Important information

1. Software update **SET3701**
2. Diagnostic function
3. Change position of Pin 1
4. New cable **FB3702**

Because of the migration to RoHS-compliant products the board **APCI-3701** has been revised.

The photo shows a new **APCI-3701**.

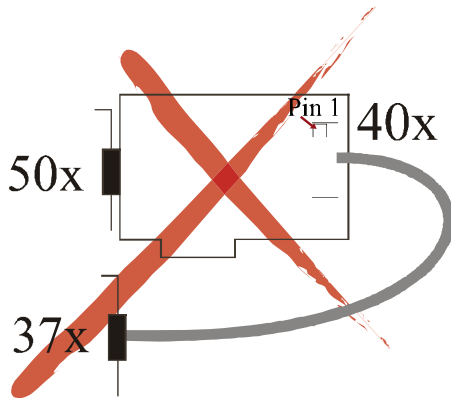
i Because of the migration to RoHS-compliant ADDI-DATA products, the board **APCI-3701** has been revised. Thus, it is necessary to **update** the software!

Please observe that you must use the calibration and update tool **SET3701** from **version 3030-1006** for the new board. Please find the current version of **SET3701** on the delivered CD.

If you replace an old board by a new **APCI-3701**:
Uninstall the old version of **SET3701** and install the new version of **SET3701**.

3. Position Pin 1 of the connector ST3

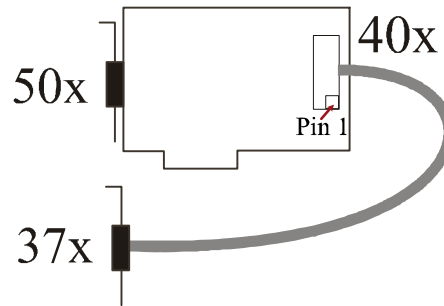
Old:

APCI-3701 before the change to RoHS-compliant

New:

APCI-3701 after the change to RoHS-compliant
